The Heights -Howard and Winthrop from Ivy to Arlington and Arlington from Howard to Winthrop and all associated catch basins. - OP 7 20240020401

THE HEIGHTS SITE REDEVELOPMENT

ORDINANCE PERMIT 07

AS-BUILTS

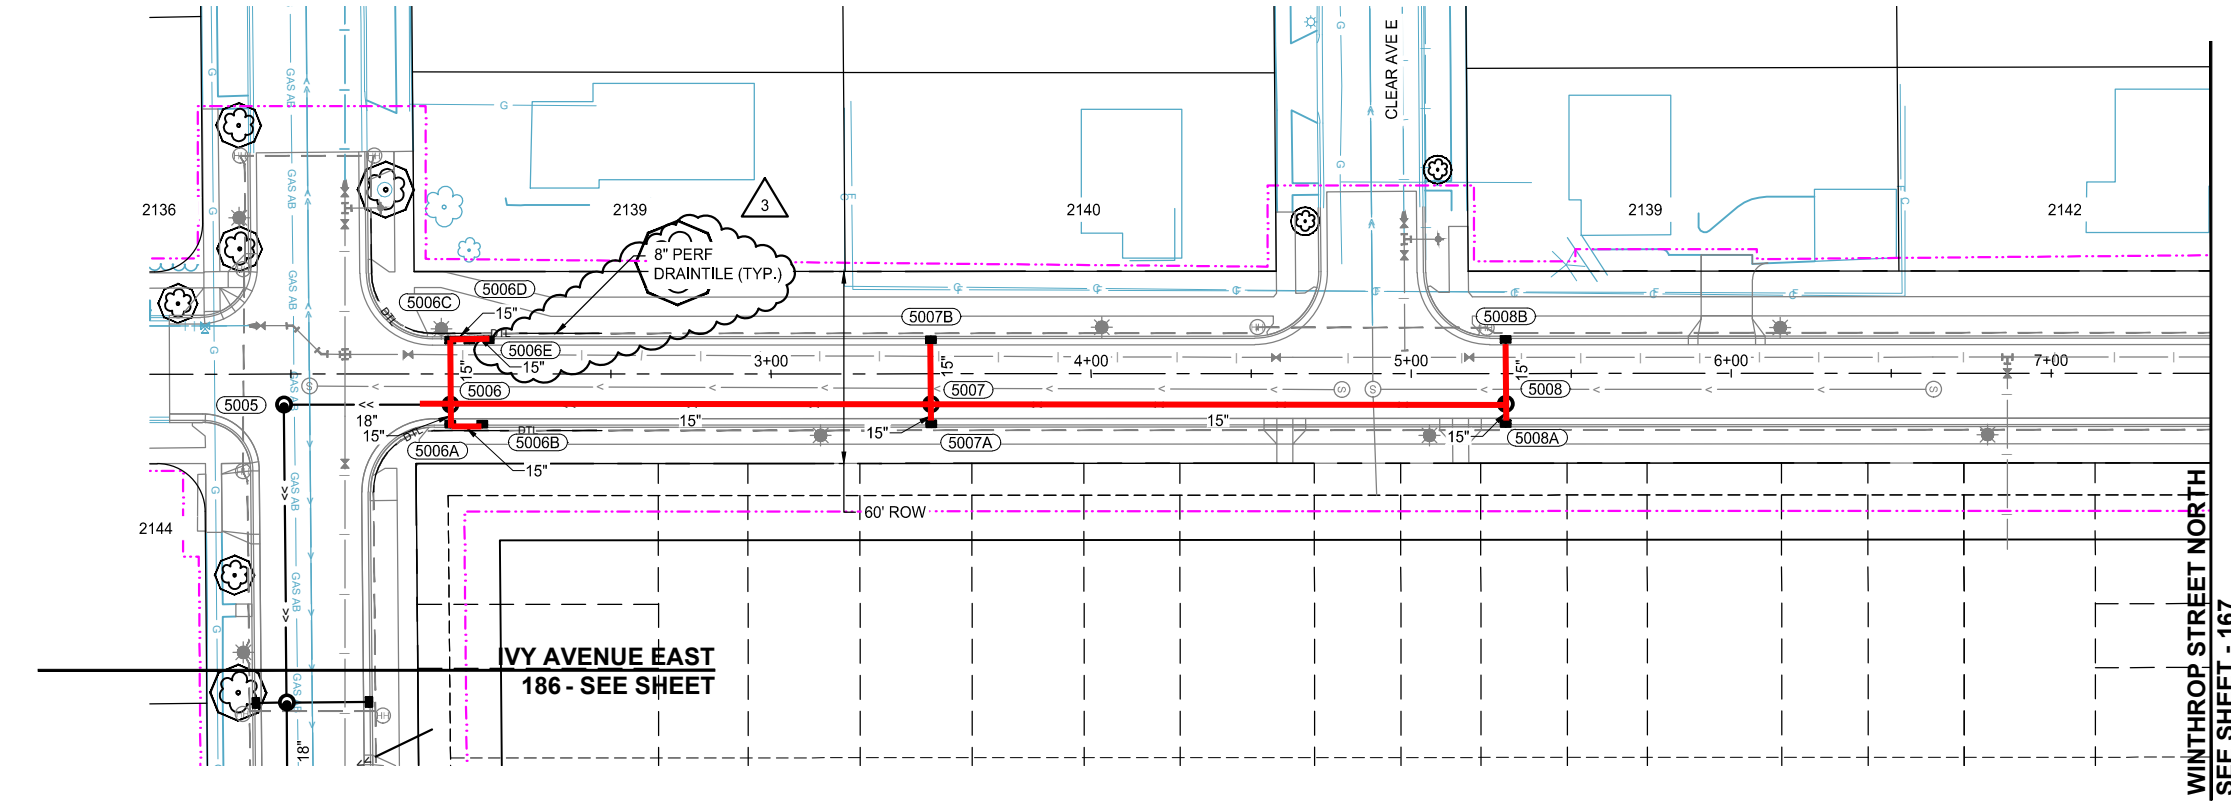
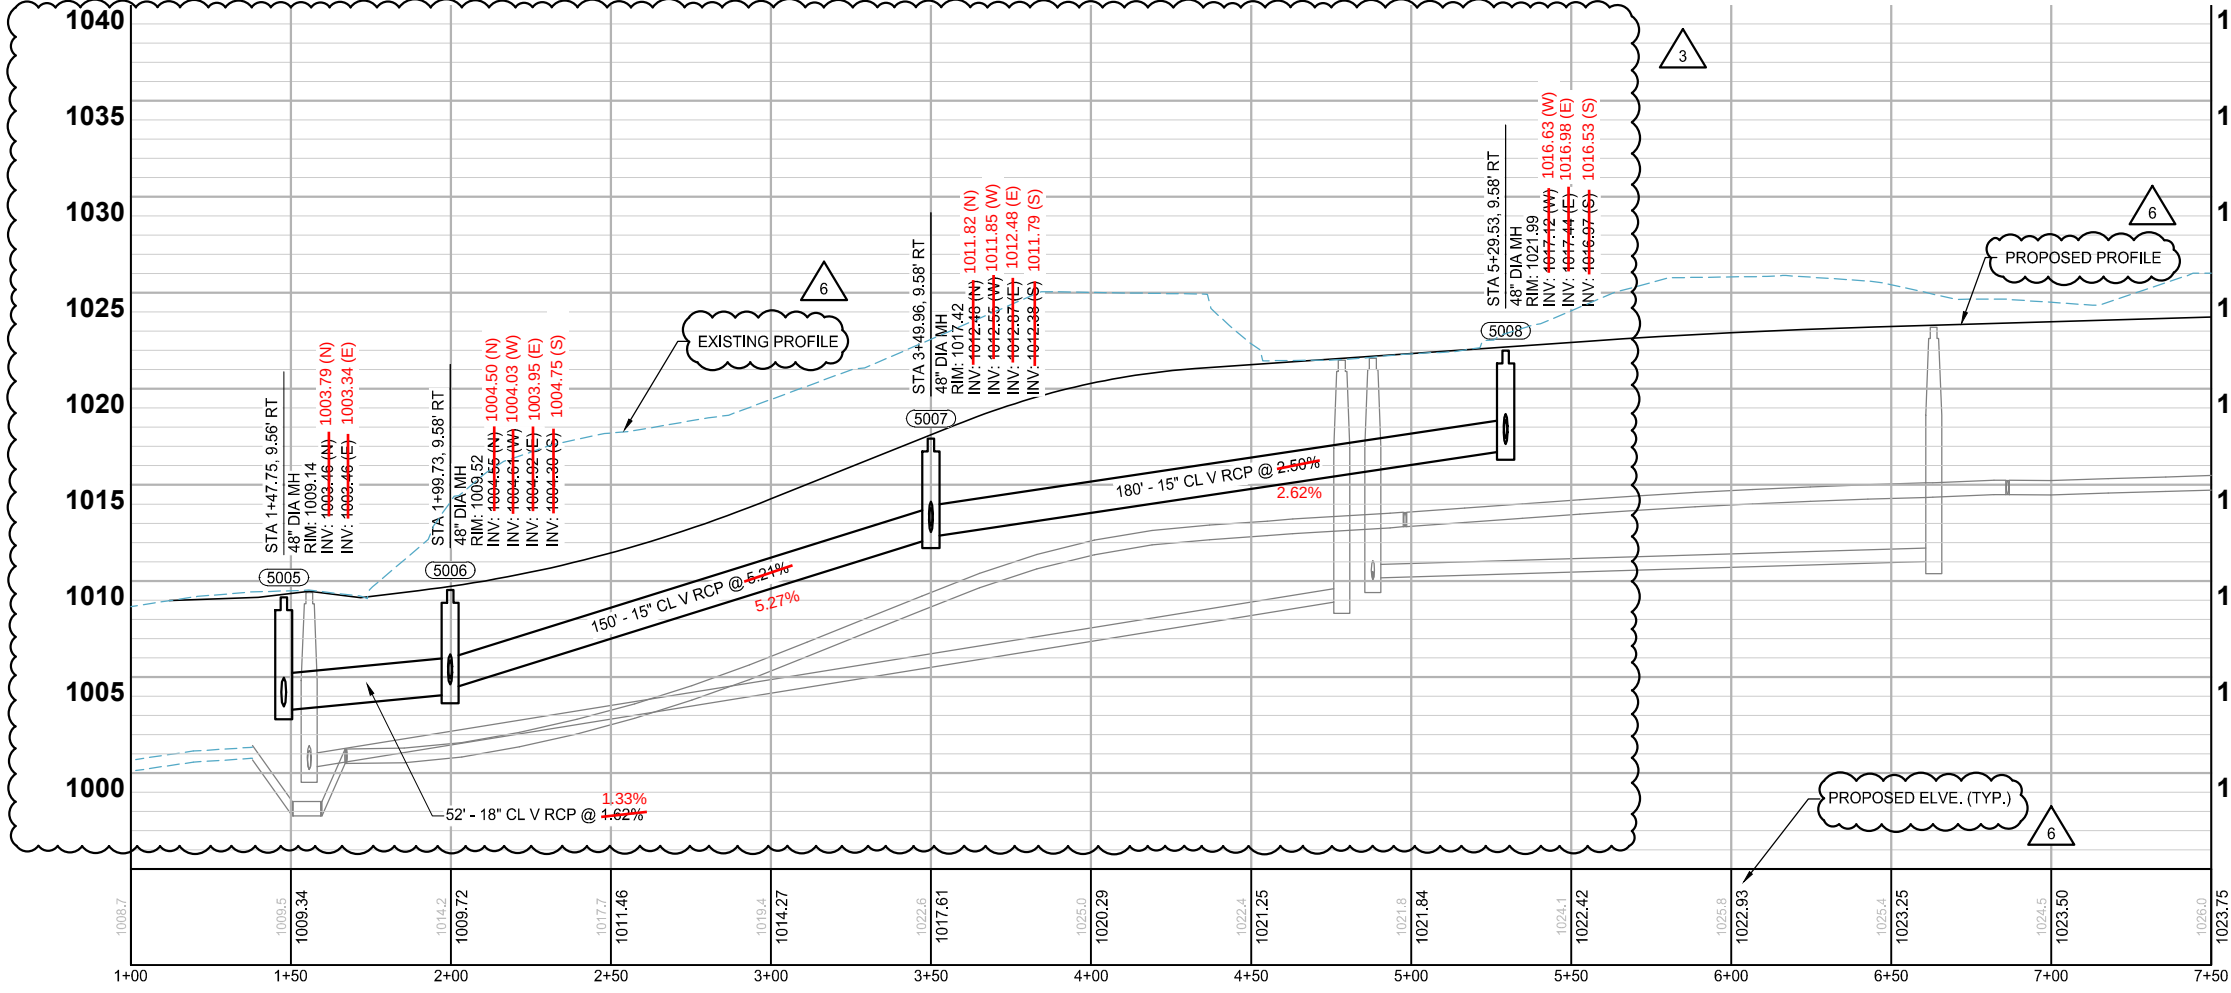
Note: As-built documents 12 LF of 18" RCP south of Structure 5006.
Remaining 40 LF were included in Ordinance Permit 20240020402.

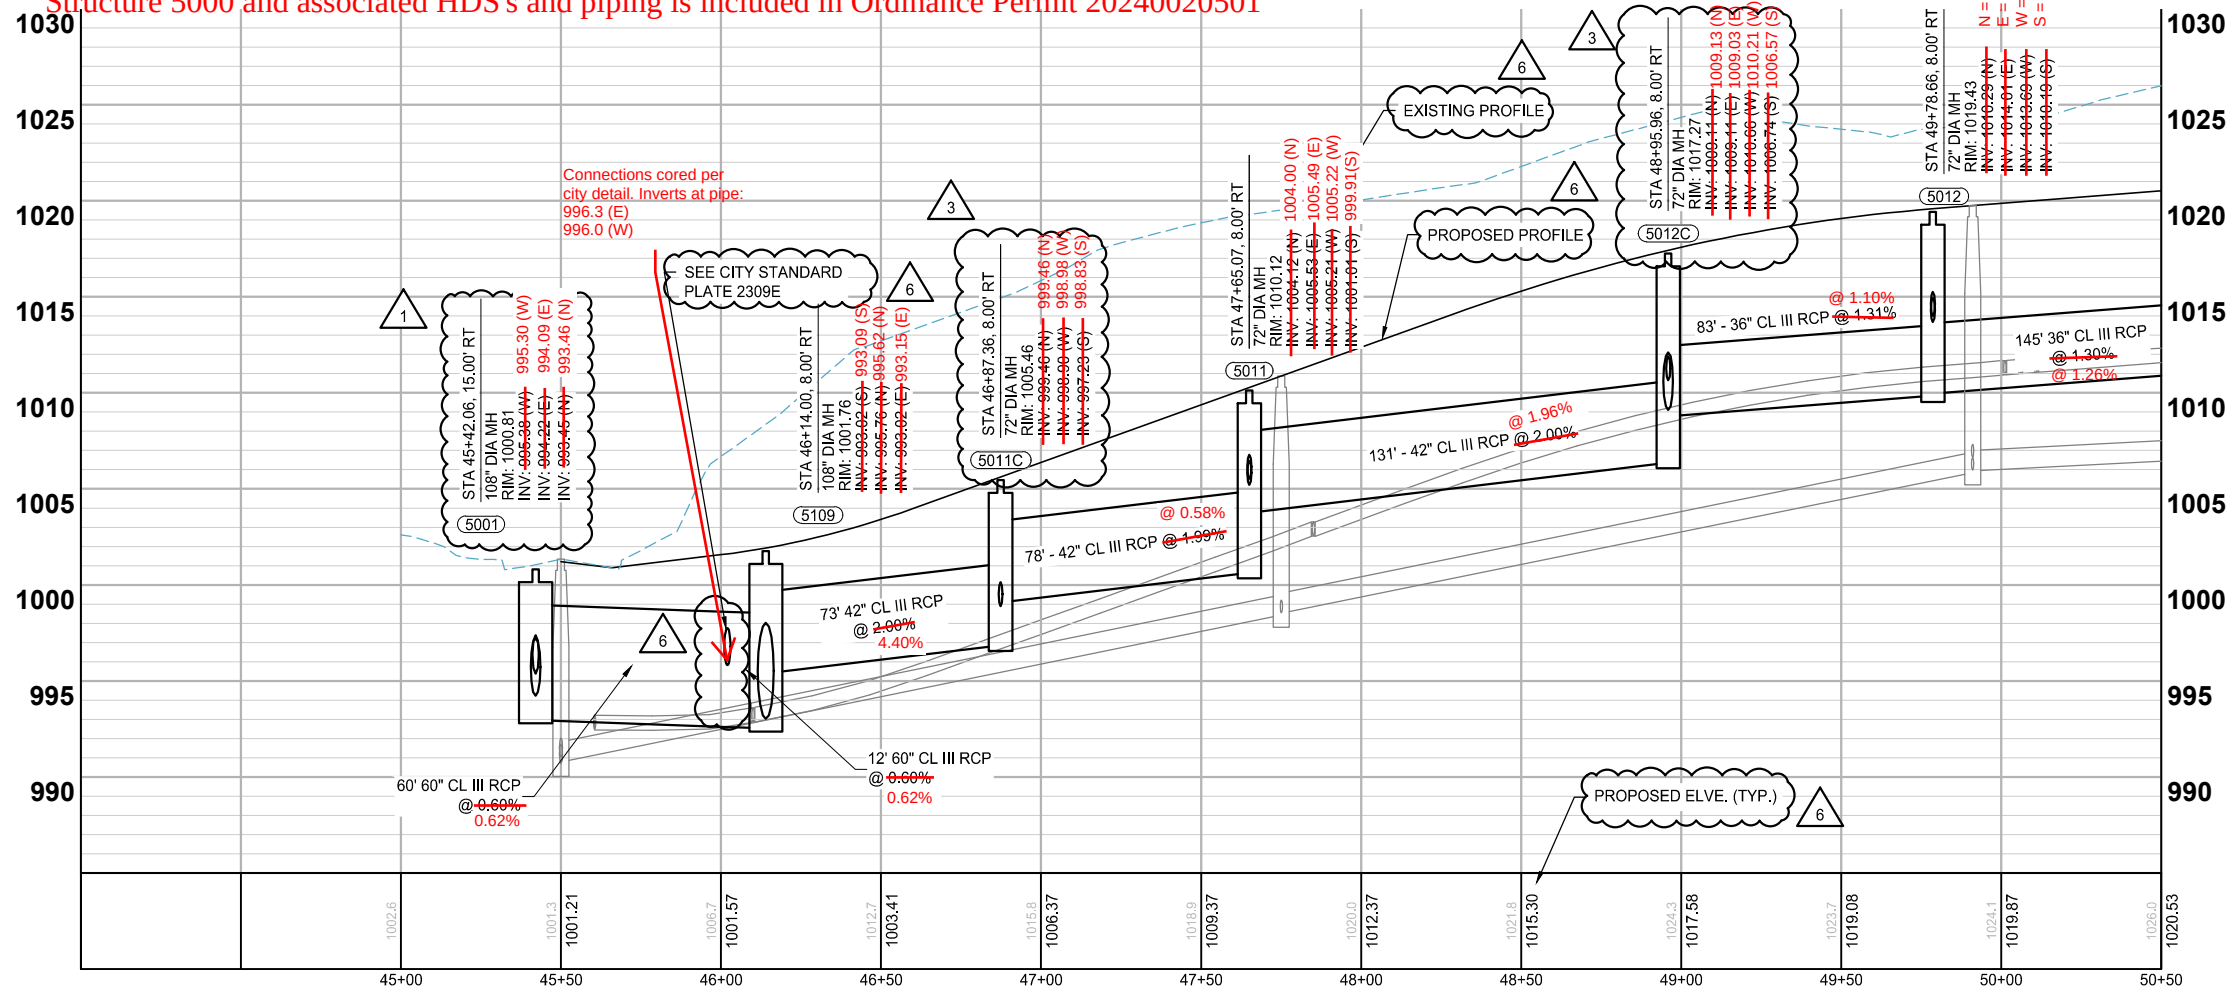
Notes: As-built documents 10 LF of 60" RCP south of 5009. Remaining 50 LF of 60" RCP included on Ordinance Permit 20240020402
Structure 5000 and associated HDS's and piping is included in Ordinance Permit 20240020501

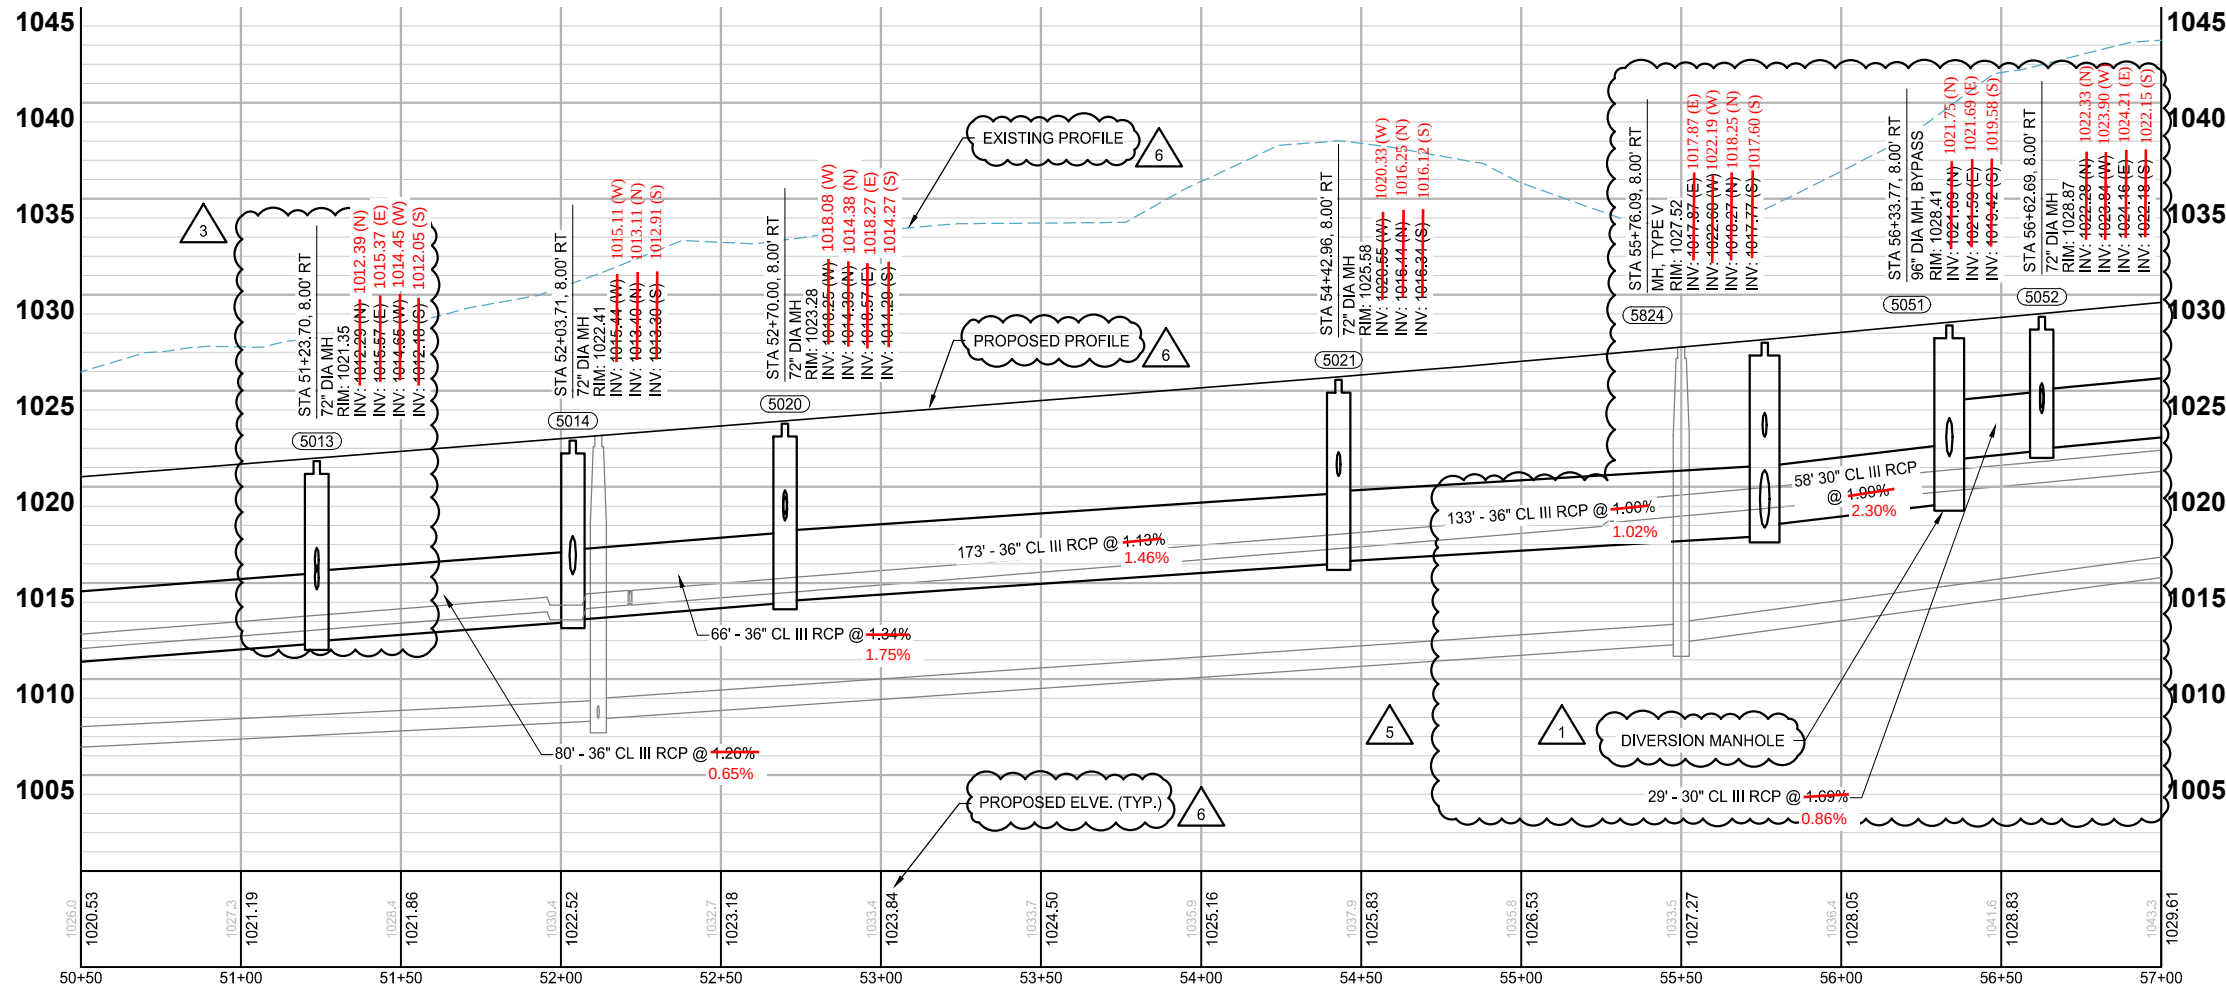
Notes: Structures HDS-01 and OCS-06 and associated piping is included in Ordinance Permit 20240020501

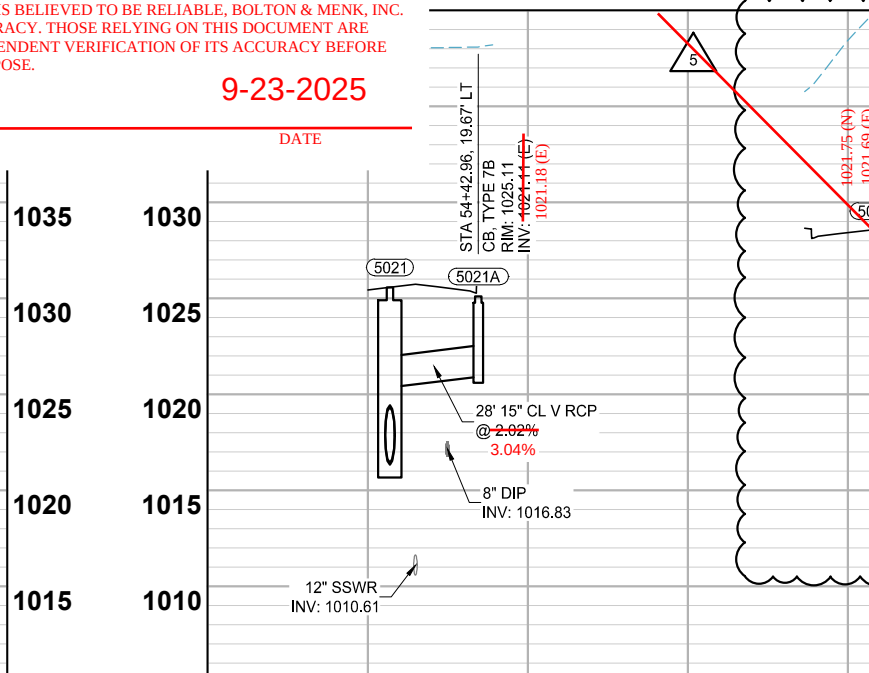
NOTE: OCS-06 COVERED IN
ORDINANCE PERMIT 20240020501
